REGULAR MEETING AGENDA

Staff Report
ALDI, Inc. – Grocery Store
1420 S. Huron Street
Preliminary Site Plan and Special Land Use Review

**Preliminary Site Plan and Special Use Review
For
Ypsilanti Township, Michigan**

RE: Aldi (1420 S Huron St)
Site Plan Review #1

GR2

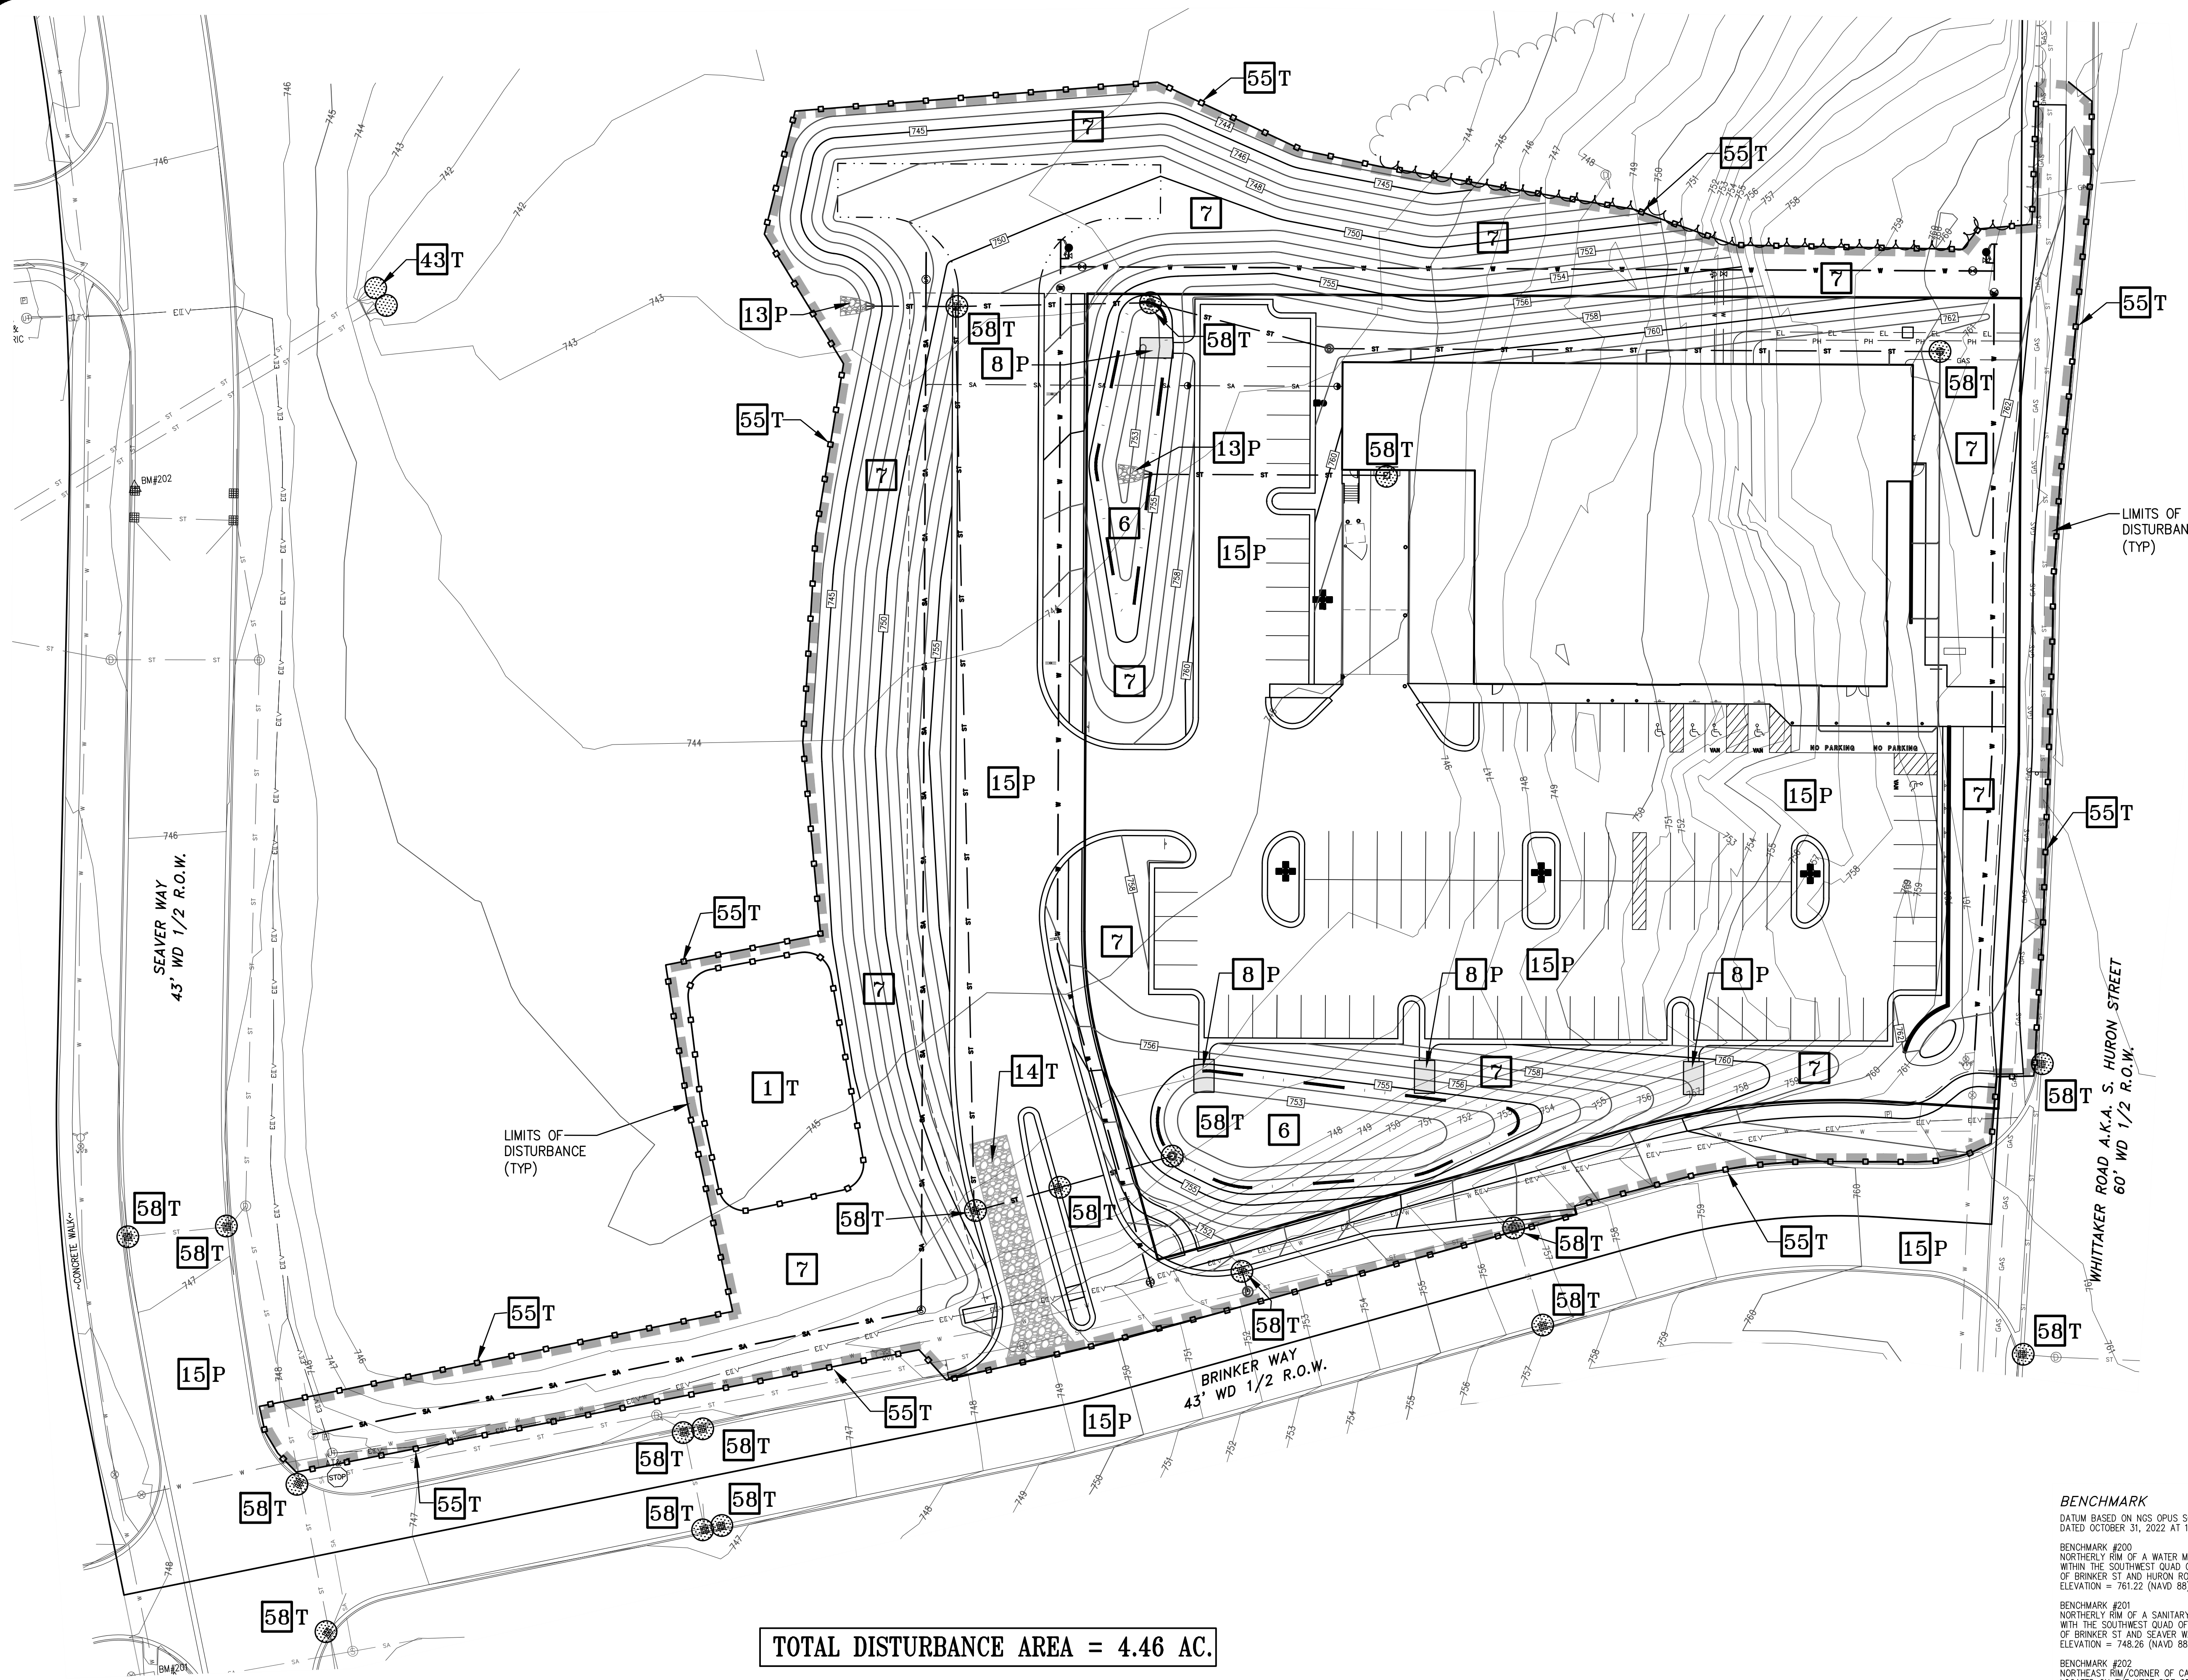
- 1) Please label the new curb and gutter on Sheet GR 1 as MDOT F4.
- 2) Please provide a pavement profile of the private driveway connecting with Brinker Way.

SE2

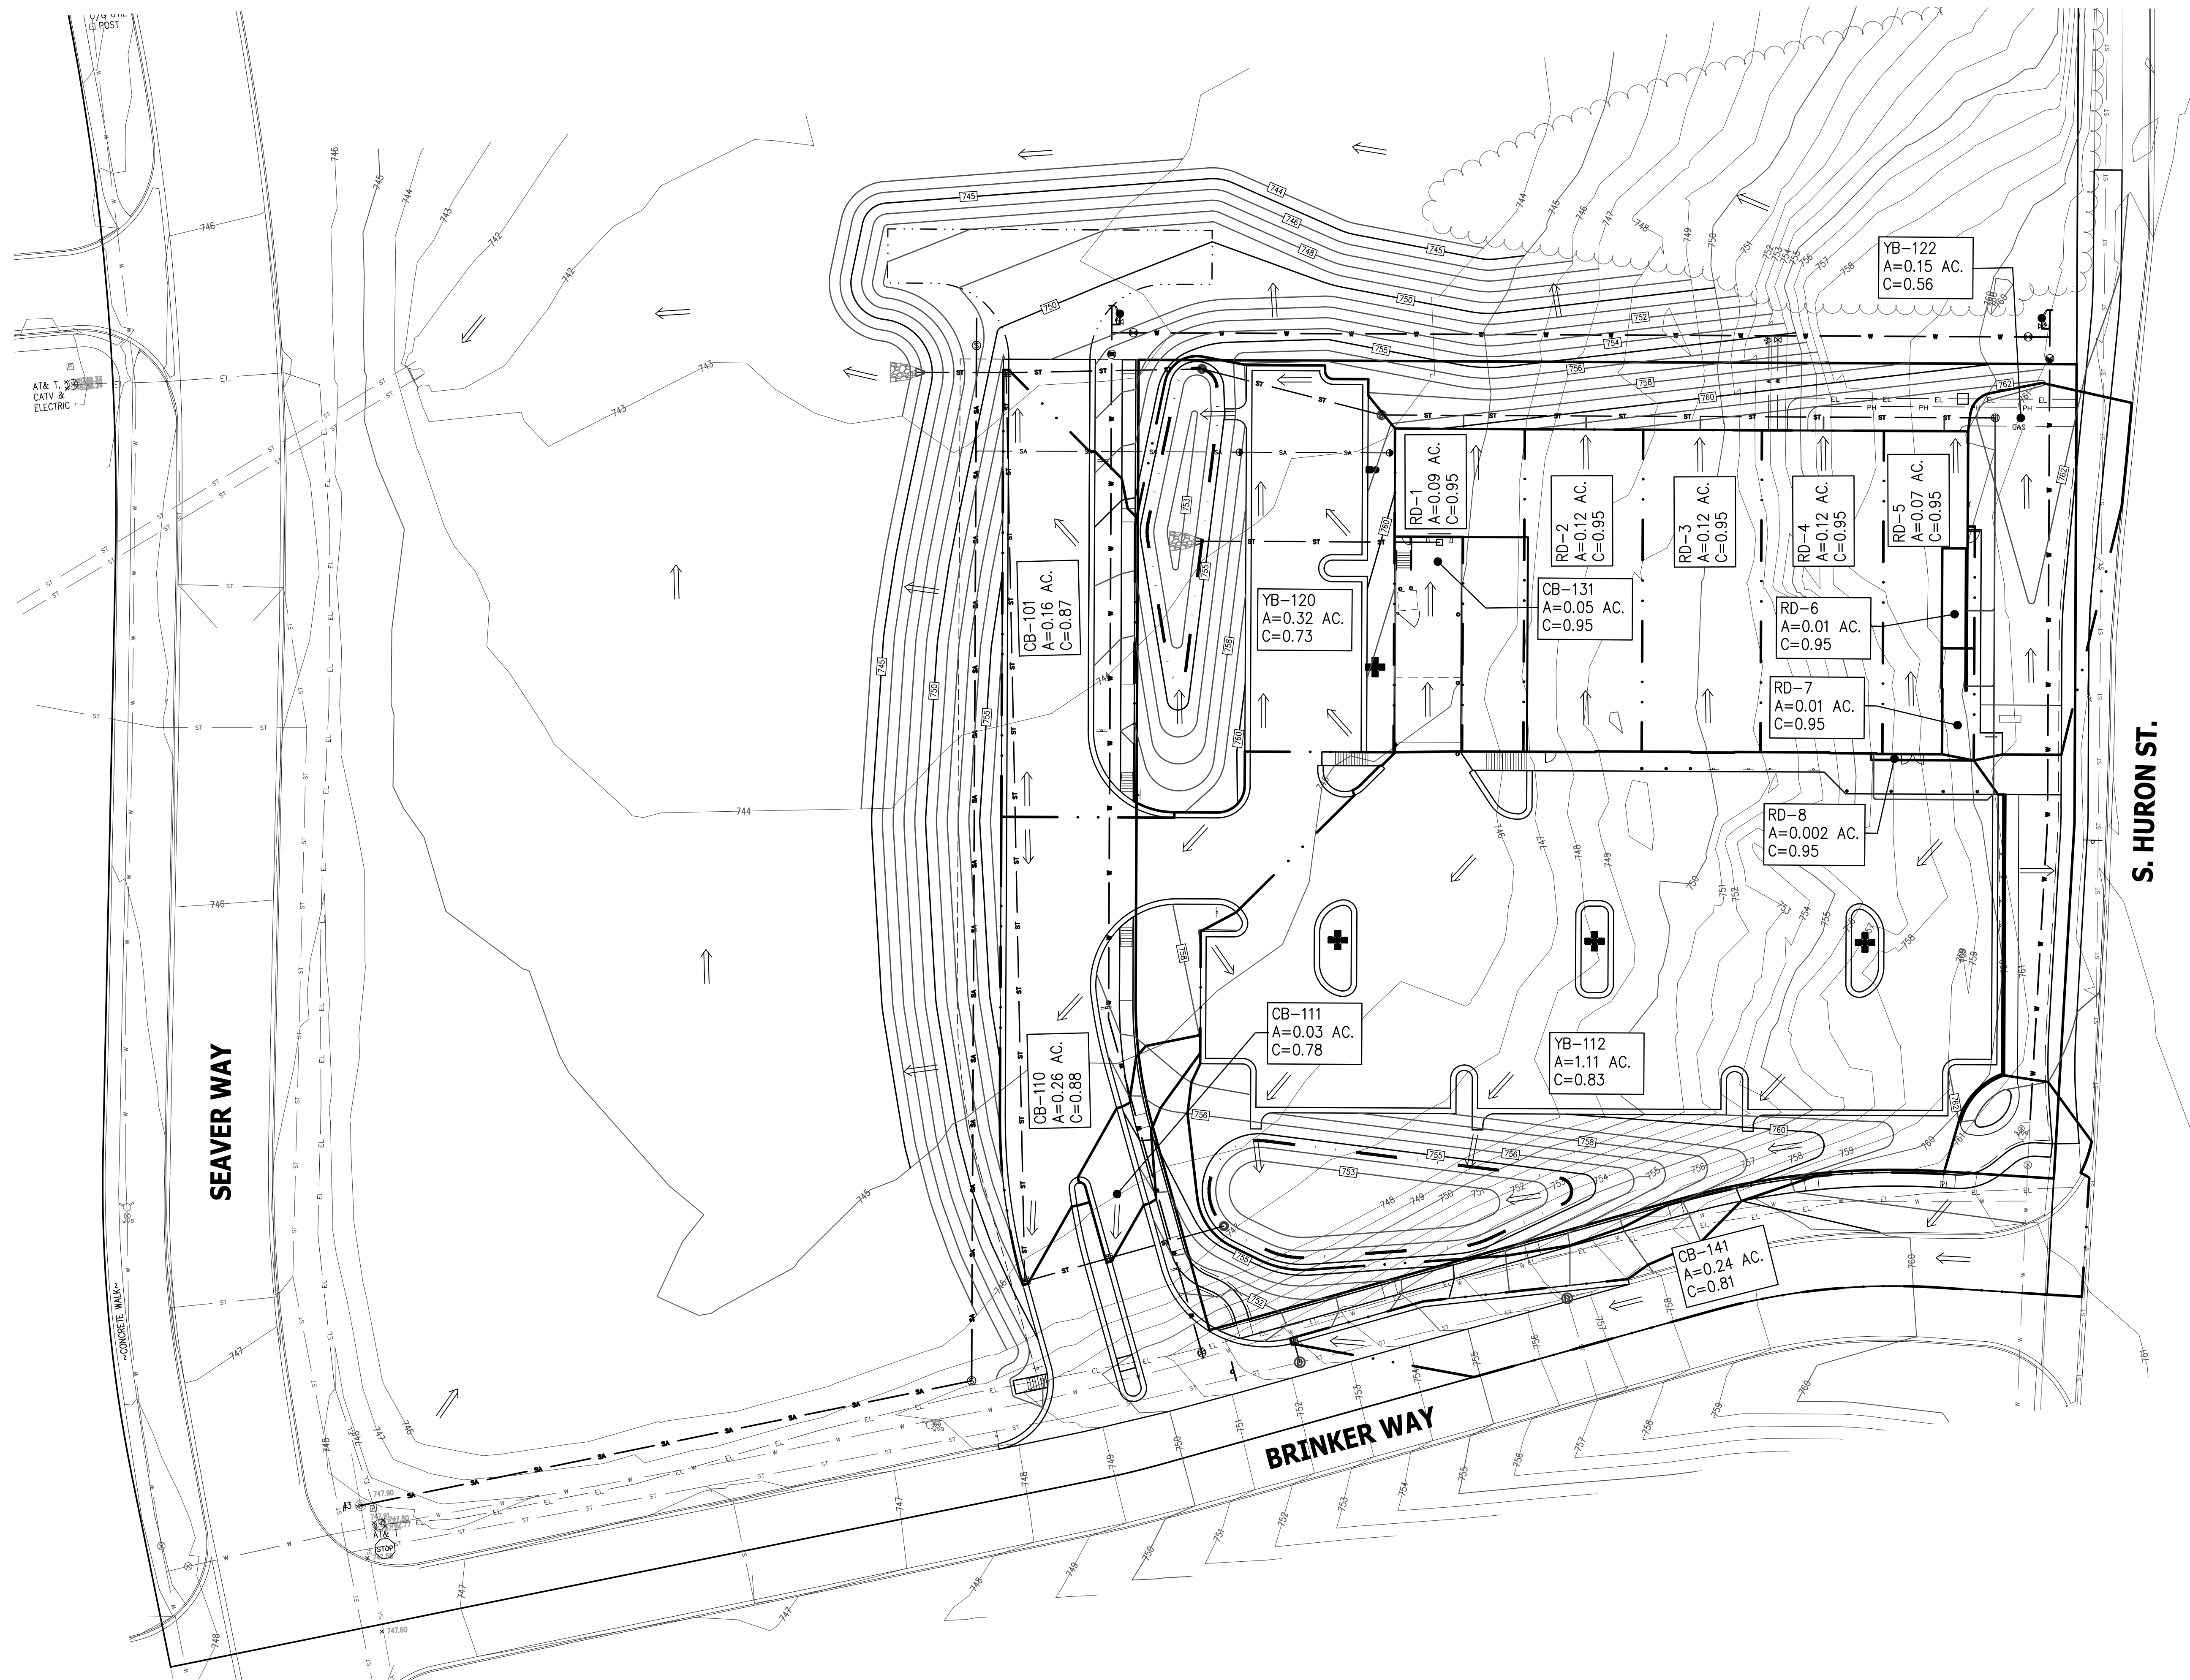
12. The applicant shall provide a utility crossing table to ensure sufficient clearance between existing and proposed utilities is provided.
13. The applicant shall revise the reference to Allendale (Sheet SE2).
14. The applicant shall provide a quantity list for all proposed utilities (water, sanitary, storm) on the Cover Sheet, delineated by existing or proposed road right-of-way or easement, per Township Standards.
15. The applicant shall provide the applicable Ypsilanti Township Standard Detail Sheets within the plan set. These Sheets can be obtained by emailing stacie.serदार@ohm-advisors.com. The applicant shall also provide the Ypsilanti Township SESC Standard Detail Sheet and revise the details on Sheet SE2.
